| TSB # | TSB 25-03 | | |
| Description/Title: | Floor Model 17D Ceiling Light Dimmer Switch | | |
| Affected Product Line(s): | MY 2025-26 Coleman Van & Freedom Elite Van | | |
| Service Campaign # : | RC000329 | | |

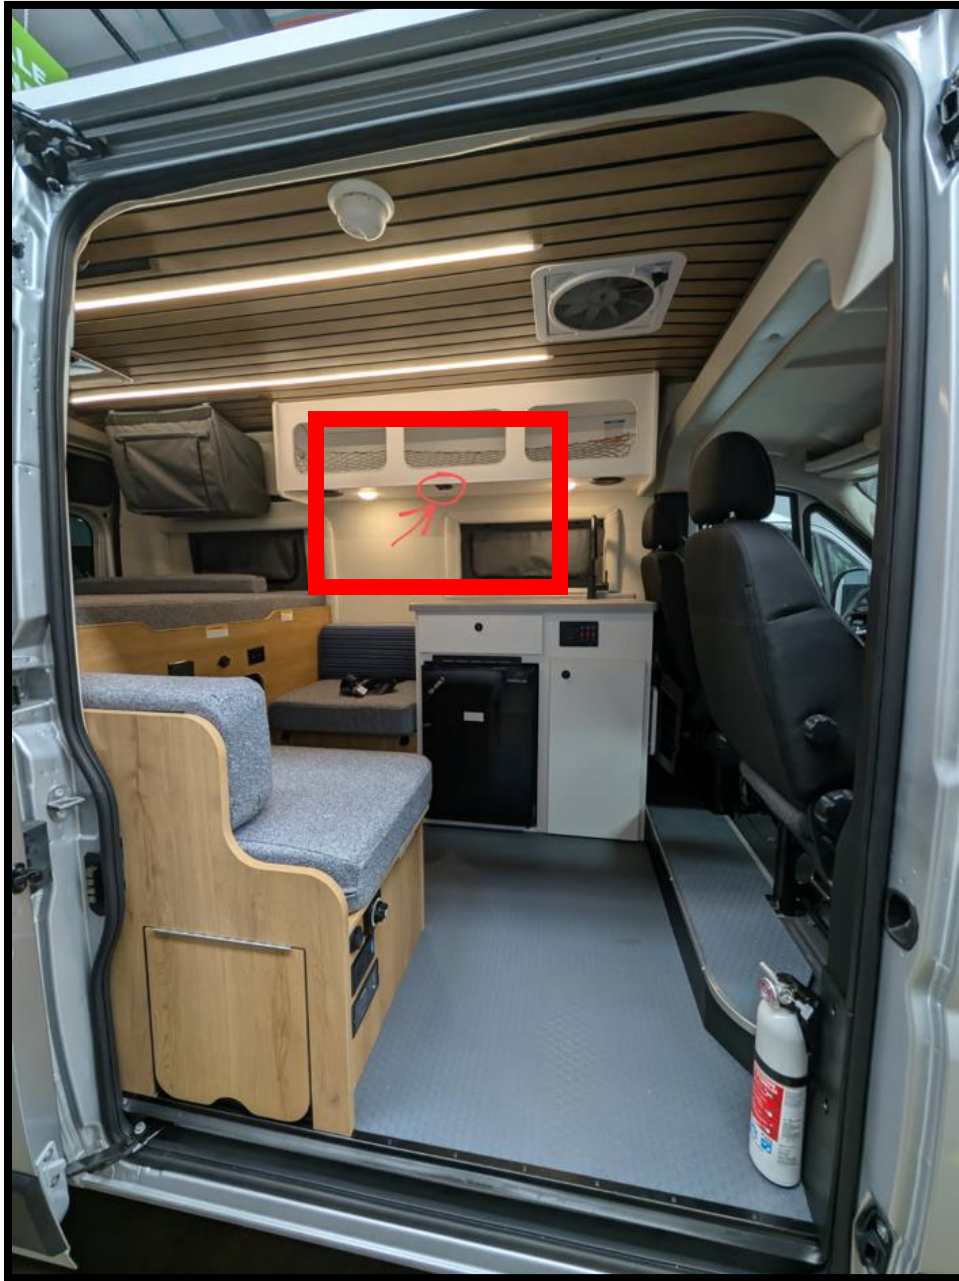
Issue:

It has been discovered the dimmer switch for the ceiling light is wired incorrectly. The light will turn on/off, but the dimming feature does not operate.

1. Locate the ceiling light switch with dimmer under the cabinet.

2. Remove the trim cover around the switch/dimmer and unscrew from the cabinet.
3. Expose the wiring behind the switch locating the butt-connectors.

4. The Red and White wires on the dimmer switch will need to be cut and swapped so the colors match up to the diagram. Use new butt-connectors to secure the wiring.
